**August 16, 2018**

Version 4

## Capless Fuel Filler (Mis-Fuel Inhibit Device) Leaks When Refueling Vehicle

Supersedes 18-014, dated April 21, 2018, to revise the sections highlighted in **yellow**.

## Civic 5-door

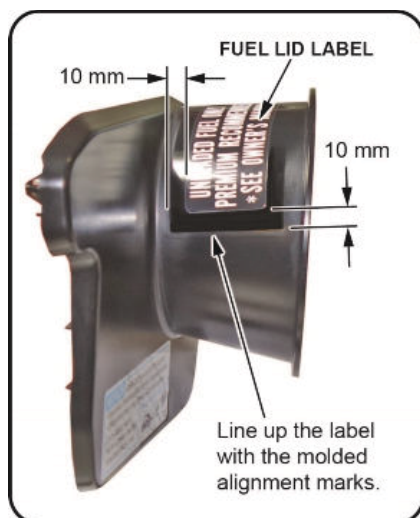
- Under AFFECTED VEHICLES, Civic 5-door was added.
- Under WARRANTY CLAIM INFORMATION, new Template IDs for Civic 5-door was added.
- Under PARTS INFORMATION, Civic 5-door part number was added.
- Under REPAIR PROCEDURE, Civic 5-door pictures and steps were added.

1. On Sport, Sport Touring, or Type R models only: Apply the fuel lid label to the new fuel lid cover as shown.

2. Align the clips on the back of the fuel lid cover to the holes in the fuel door.
